Notice of Intent

Sundry ID: 2779335

Type of Action: APD Change

Procedure Description: Mewbourne request a variance to perform break testing and offline cementing as per attached procedures to the following well: FORTY NINER RIDGE UNIT 149H 3001553311 FORTY NINER RIDGE UNIT 151H 3001549426 FORTY NINER RIDGE UNIT 152H 3001550146

Figure 1. BOP diagram

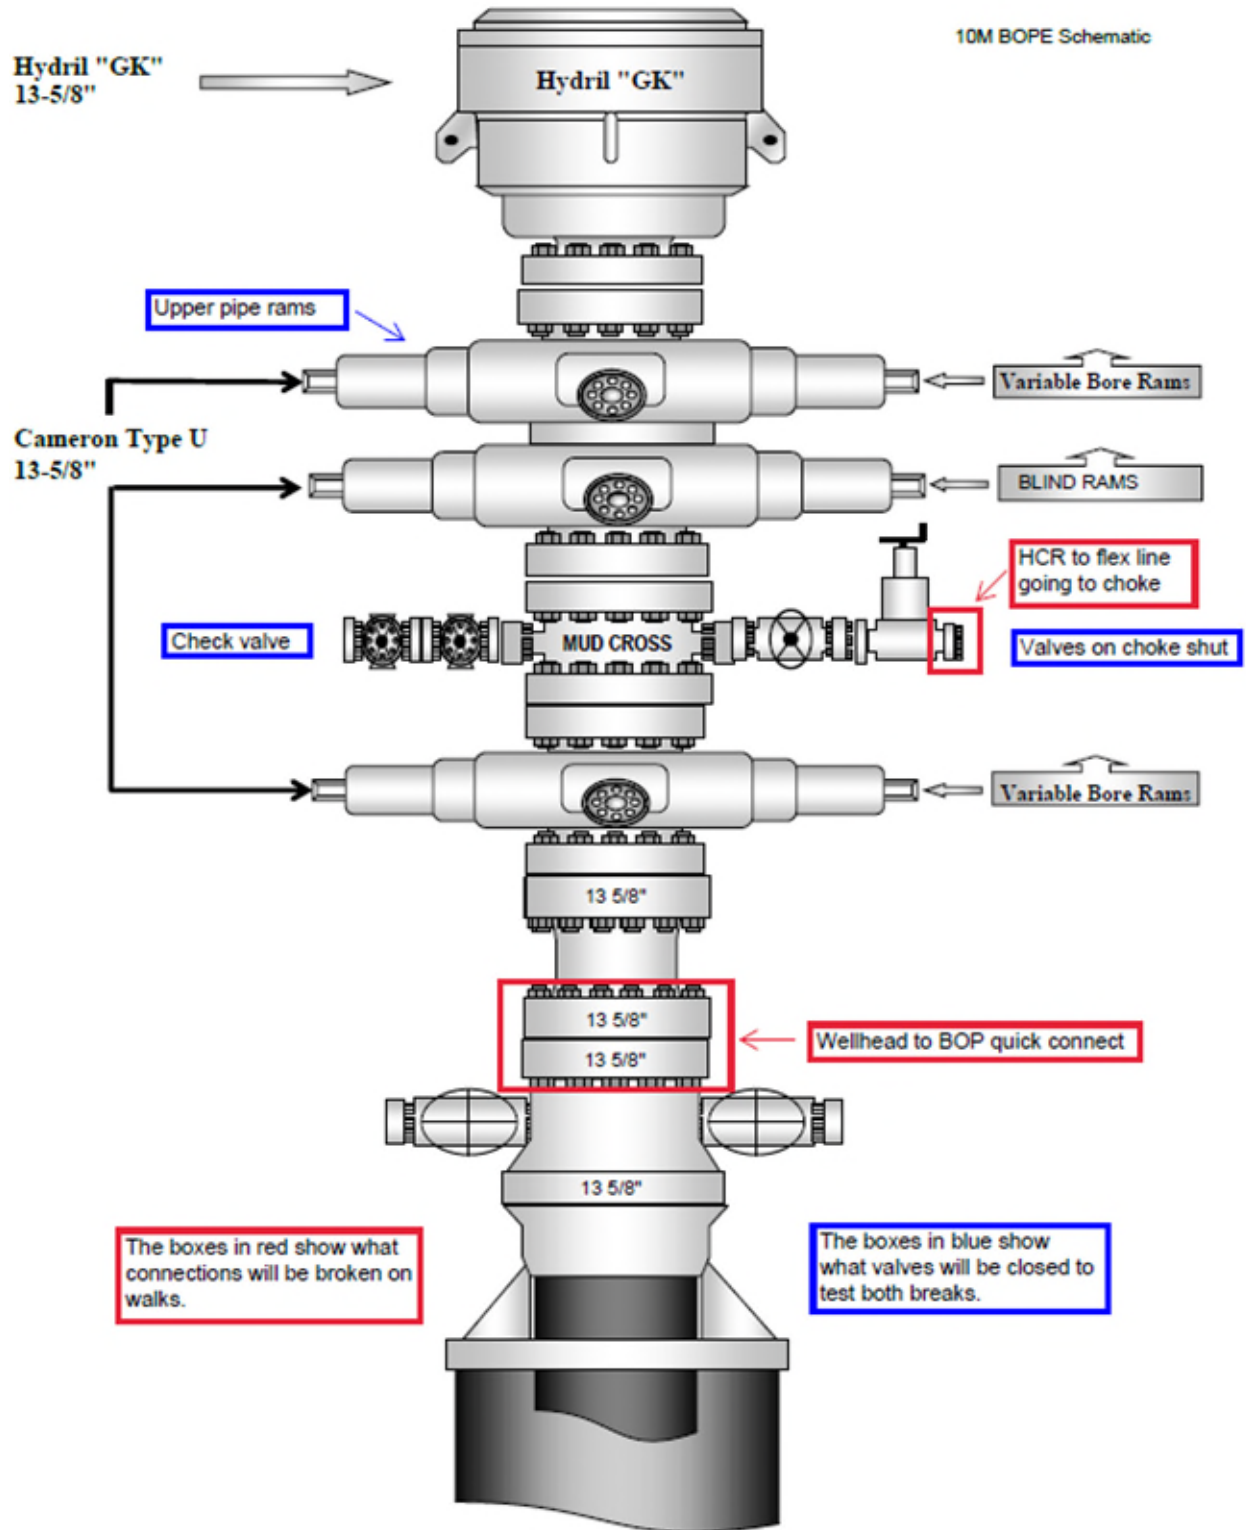
2. After the well section is secured and the well is confirmed to be static, the BOP will be disconnected from the wellhead and walked with the rig to another well on the pad. Two breaks on the BOPE will be made (Fig. 1).

9. A test will then be conducted against the upper pipe rams and choke, testing both breaks (Fig. 1 & 2).
10. The test will be held at 250 psi low and to the high value submitted in the APD, not to exceed 5000 psi.

Figure 3. BOP handling system

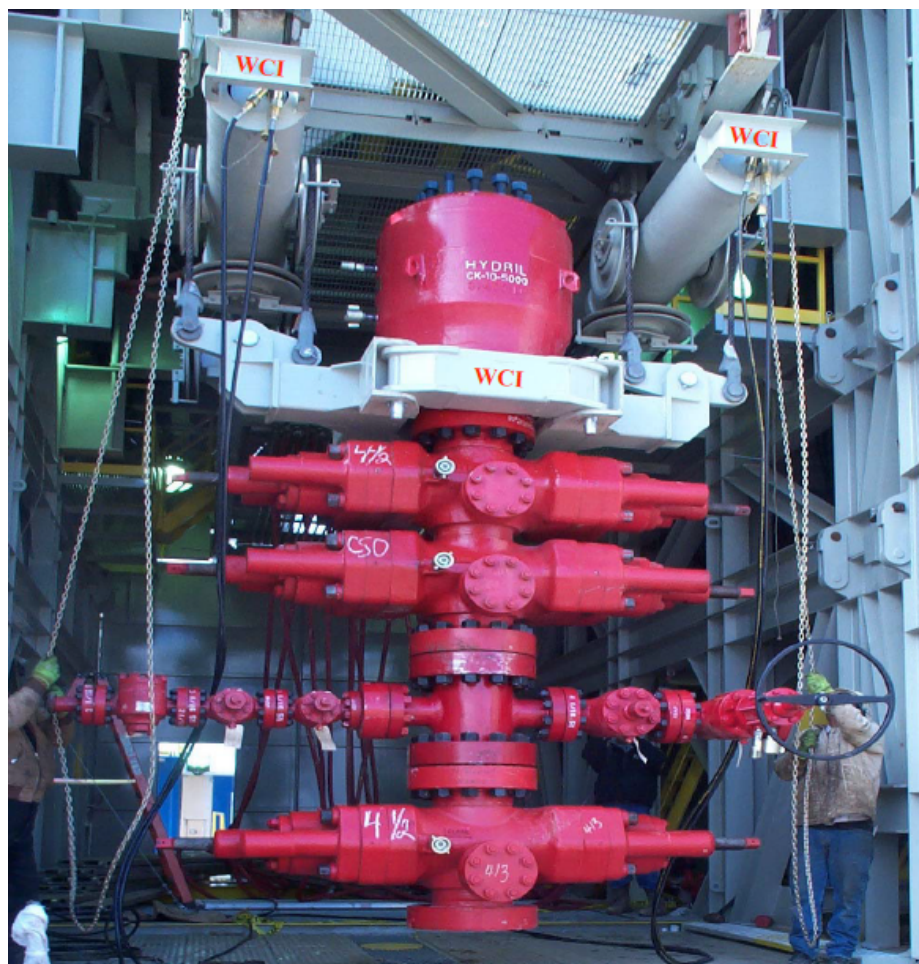
4. The BOP will be removed and carried by a hydraulic carrier (Fig. 3 & 4).
5. The rig will then walk to the next well.
6. Confirm that the well is static and remove the capping flange.

Figure 6. Vault 5M wellhead with BOP quick connect

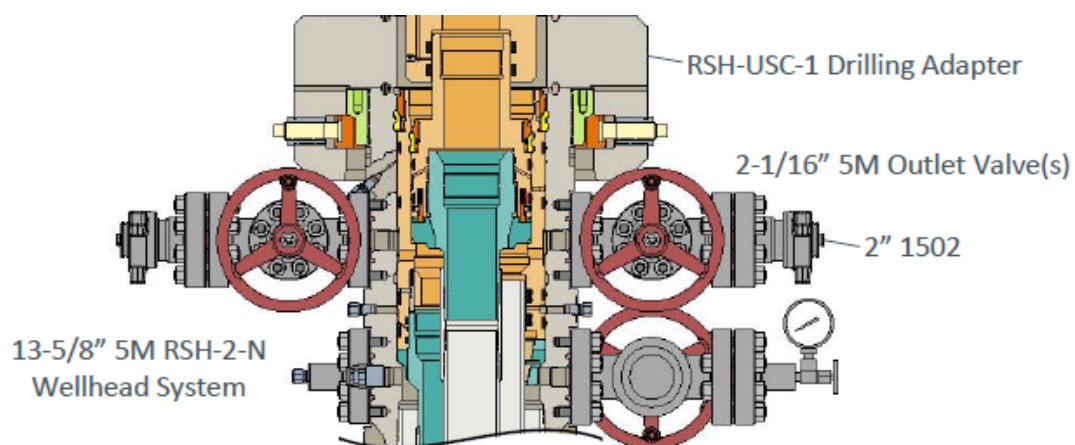
- Connection between the flex line and the HCR valve
 - Connection between the wellhead and the BOP quick connect (Fig. 5 & 6).
3. A capping flange will be installed after cementing per wellhead vendor procedure & casing pressure will be monitored via wellhead valve.

Figure 1. Cactus 13 3/8" 5M offline cementing tool. Pressure rating limited by the lesser of 5M tool rating or the 13 3/8" pup joint and casing.

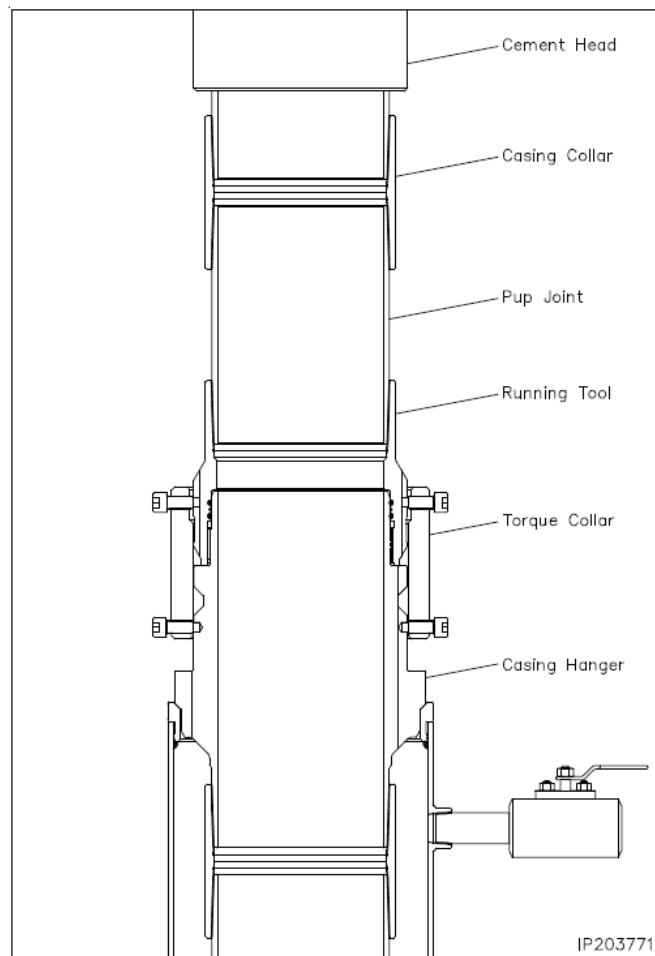
9. Make up offline cement tool with forklift per wellhead manufacturer (Fig. 1 & 2).
10. Make up cement head on top of offline cement tool with forklift.

Figure 3. Cactus 9 5/8" 5M offline cementing tool. Pressure rating limited by the lesser of 5M tool rating or the 9 5/8" pup joint and casing.

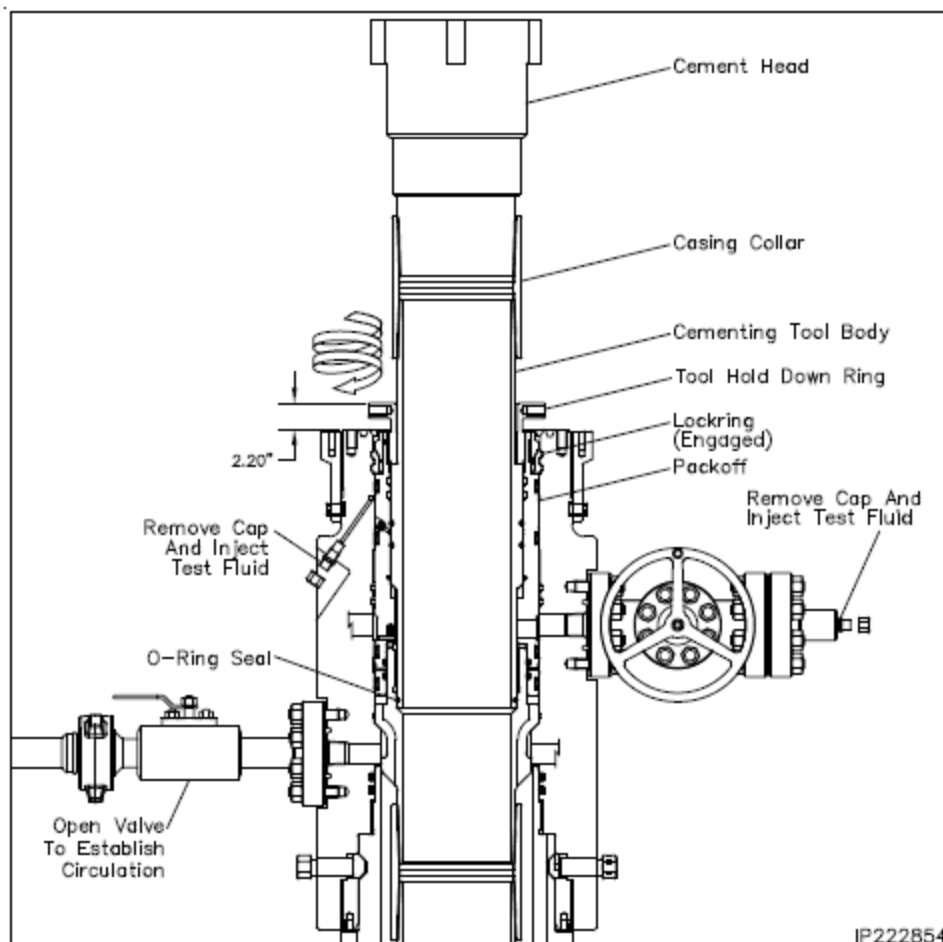
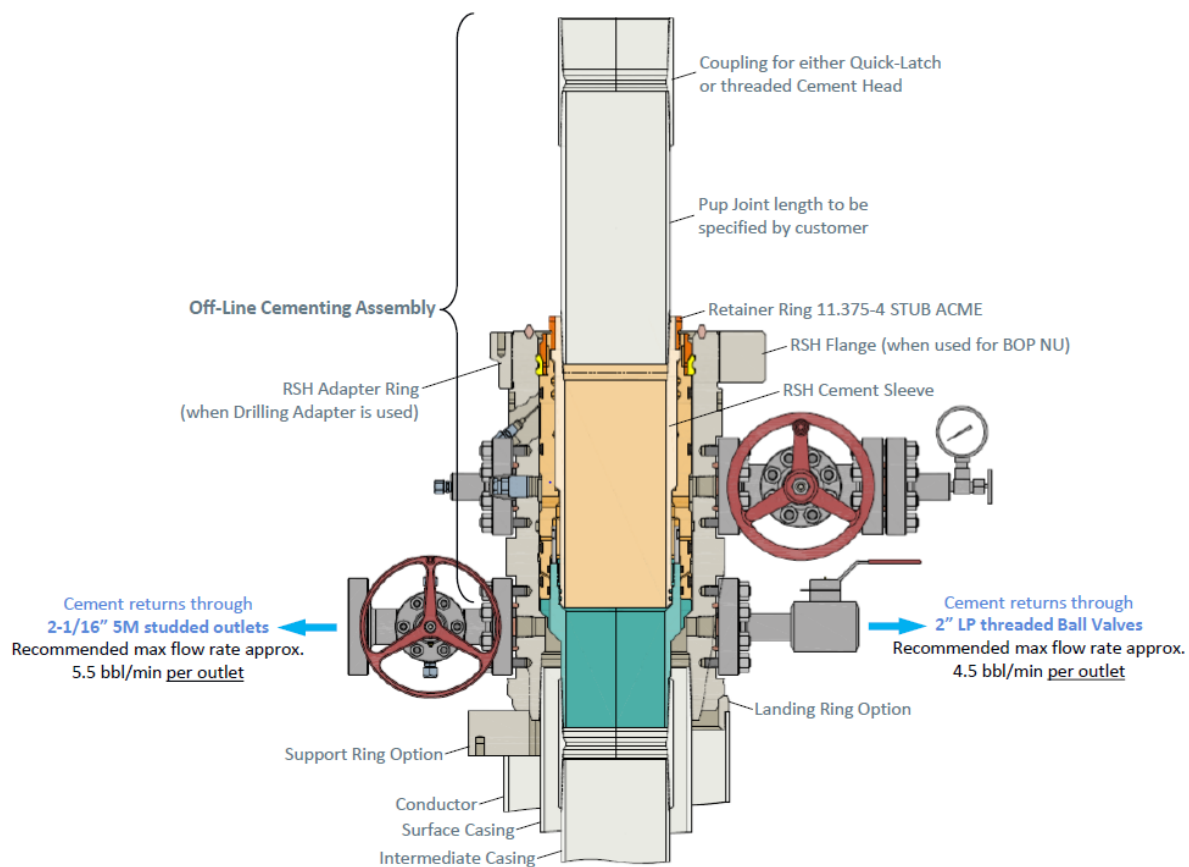
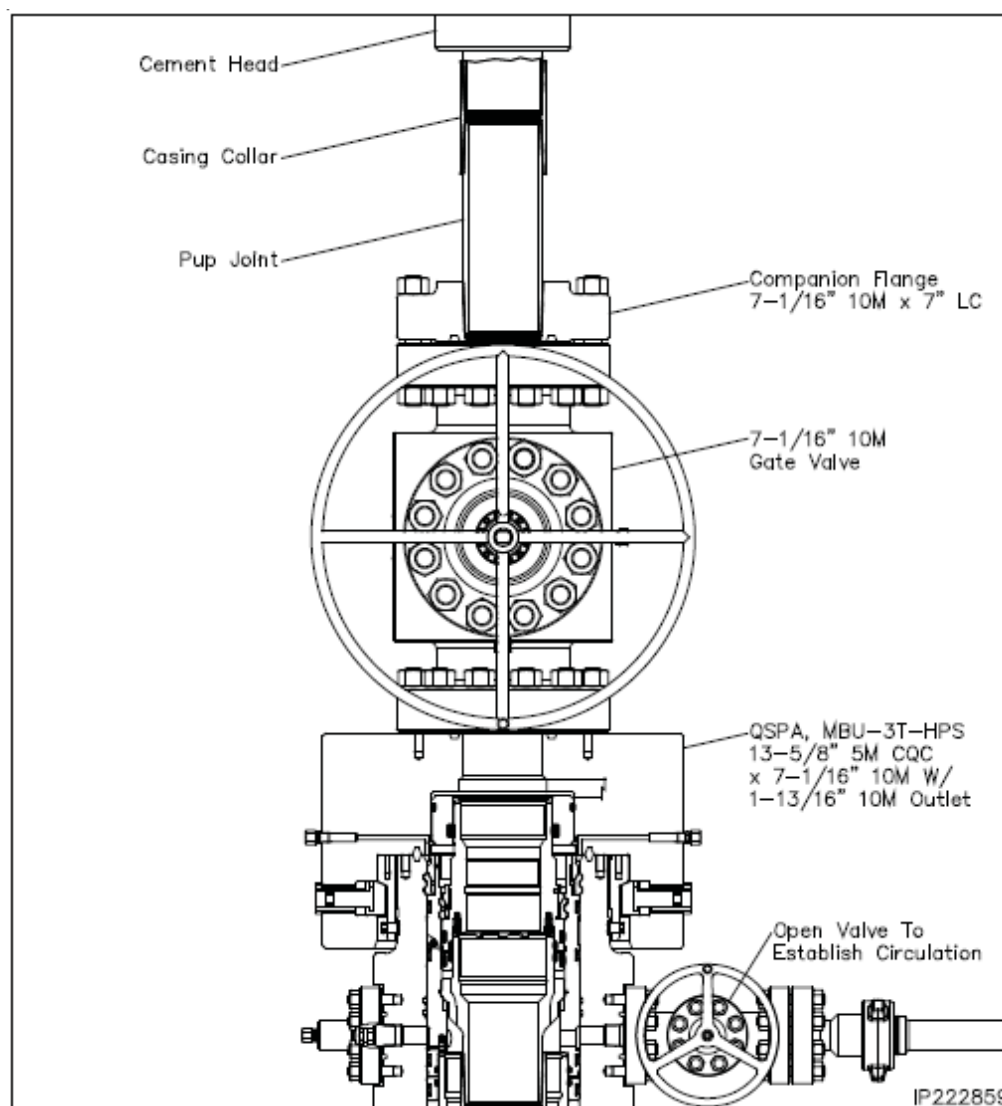
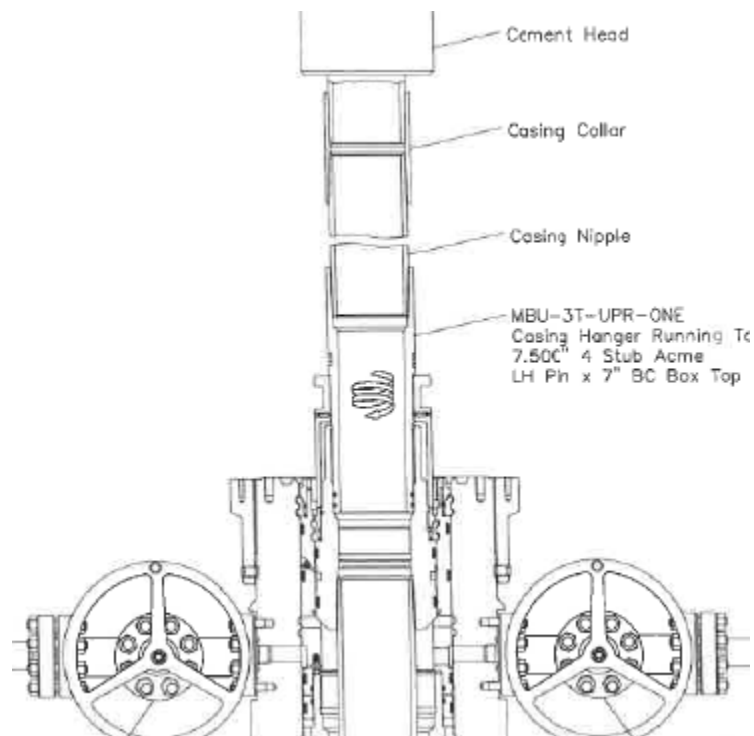
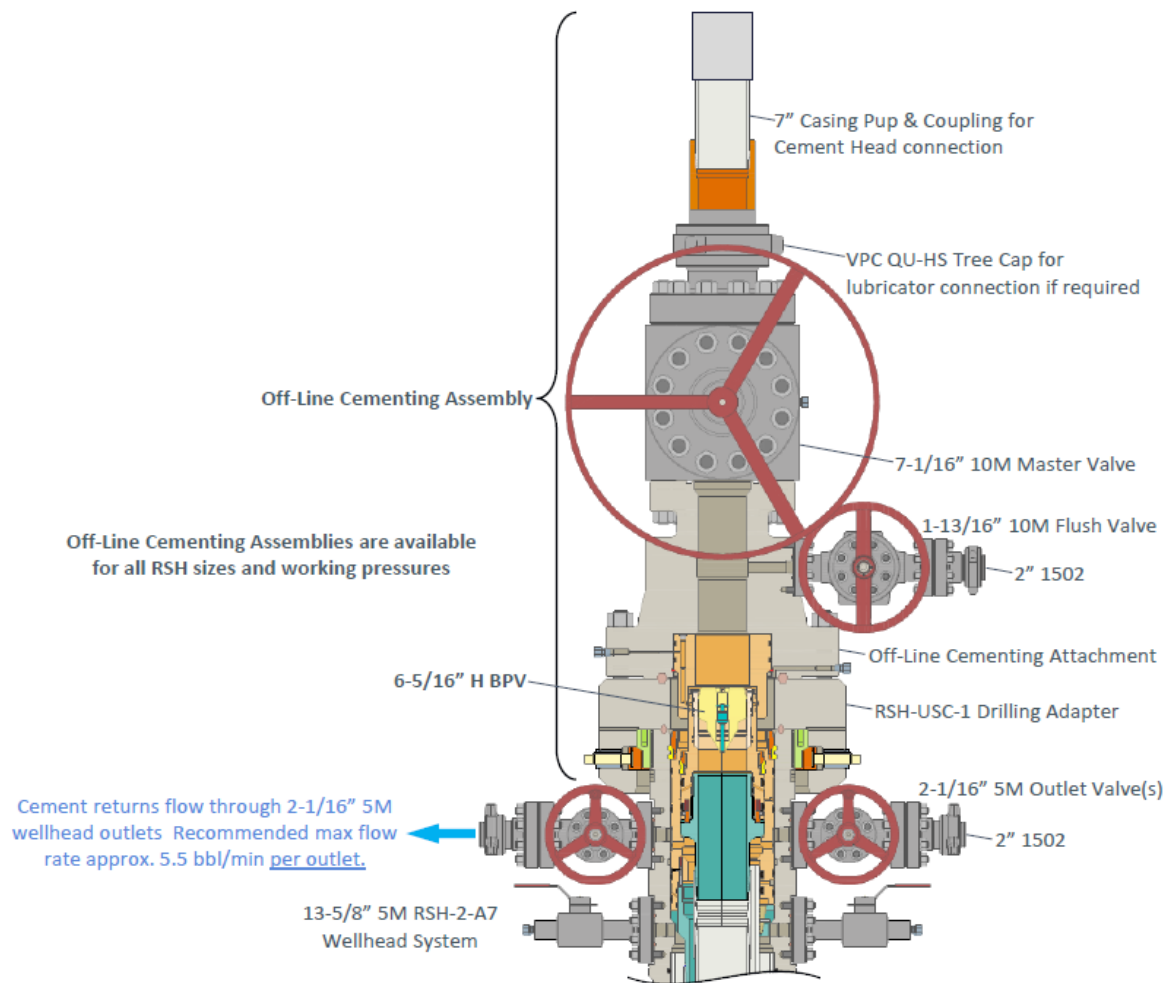
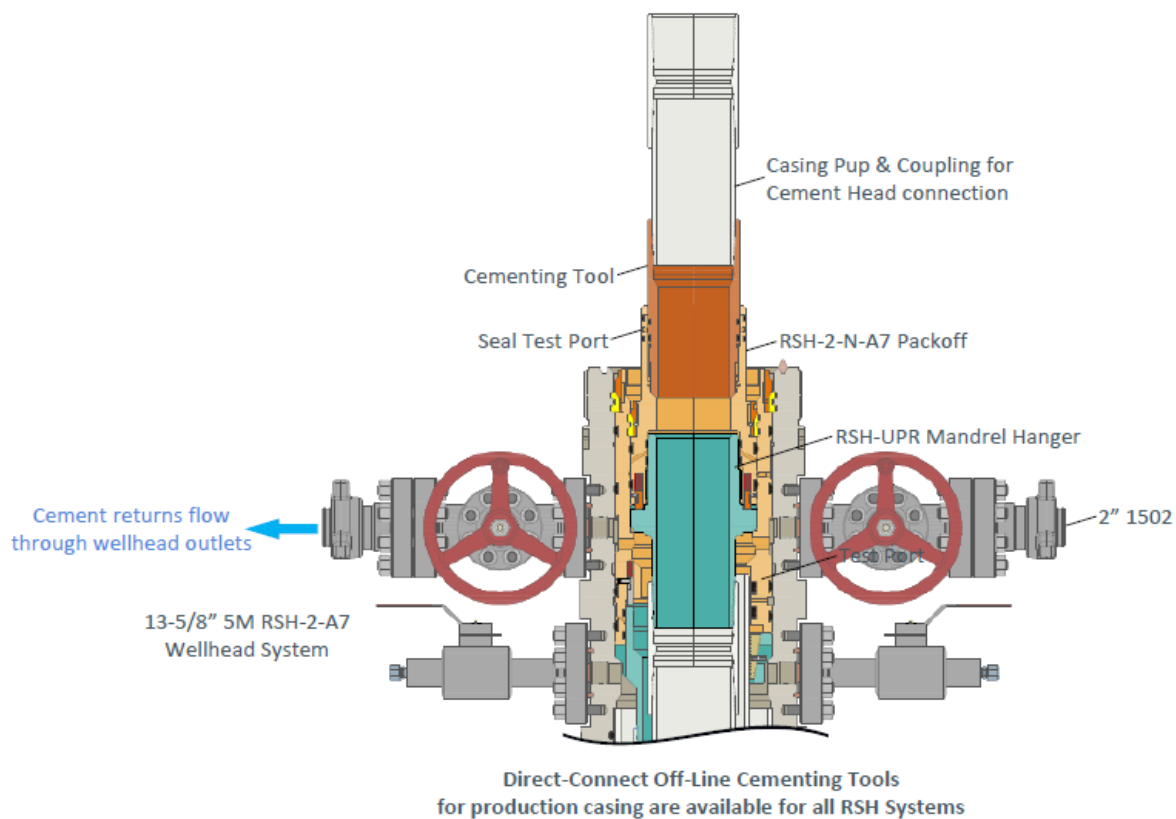
10. Make up offline cement tool using forklift per wellhead manufacturer (Fig. 3 - 8).
11. Make up cement head on top of offline cement tool.
12. Commence cement operations.

Figure 9. Five valve 15k choke manifold.

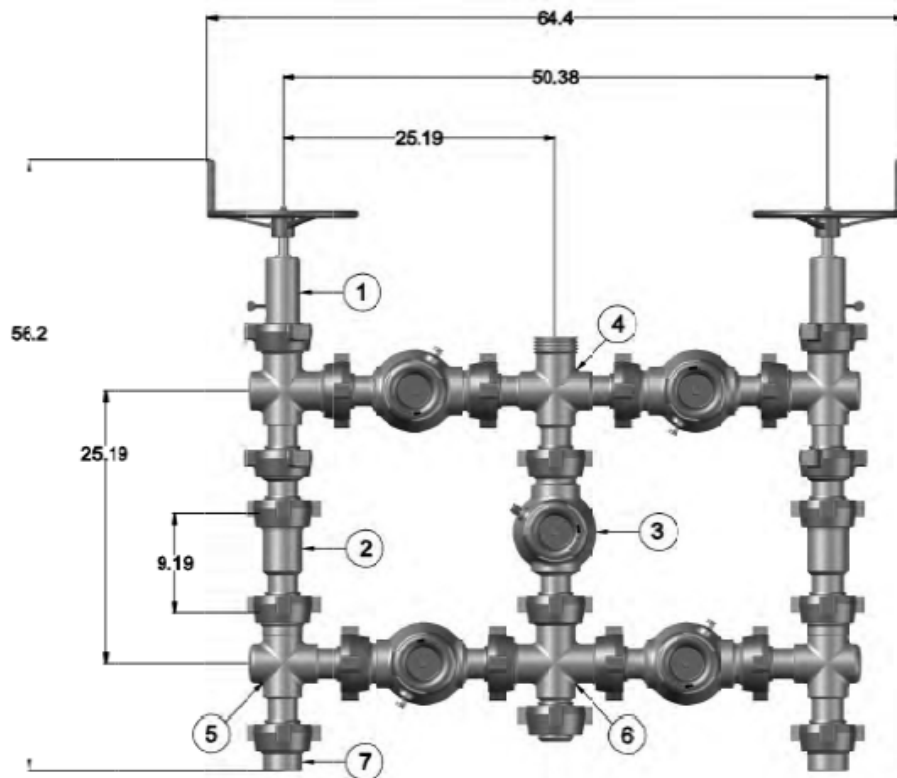
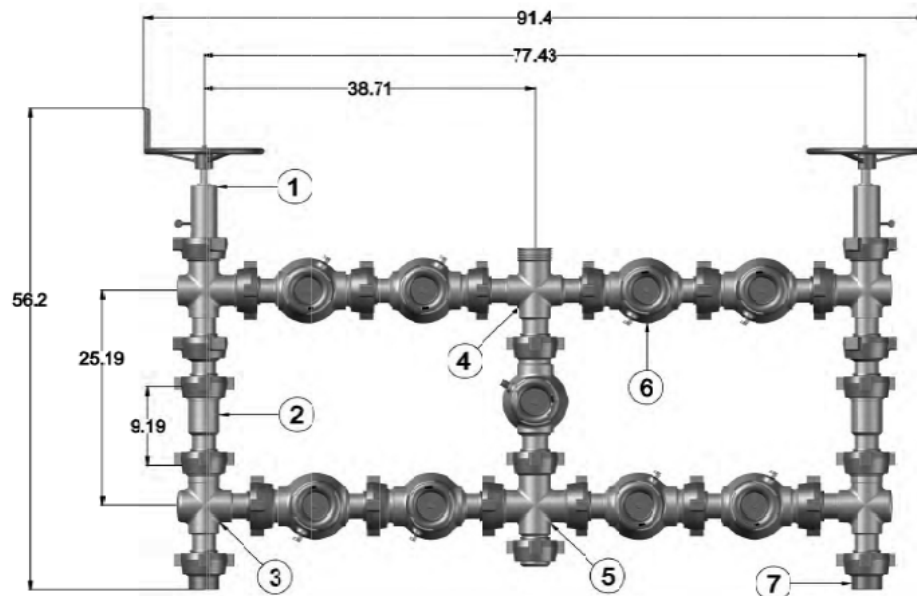
- Pressure build up in annulus before cementing
 - Contact BLM if a well control event occurs.
 - Rig up 3rd party pump or rig pumps to pump down casing and kill well.
 - Returns will be taken through the wellhead valves to a choke manifold (Fig 9 & 10).
 - Well could also be killed through the wellhead valves down the annulus.
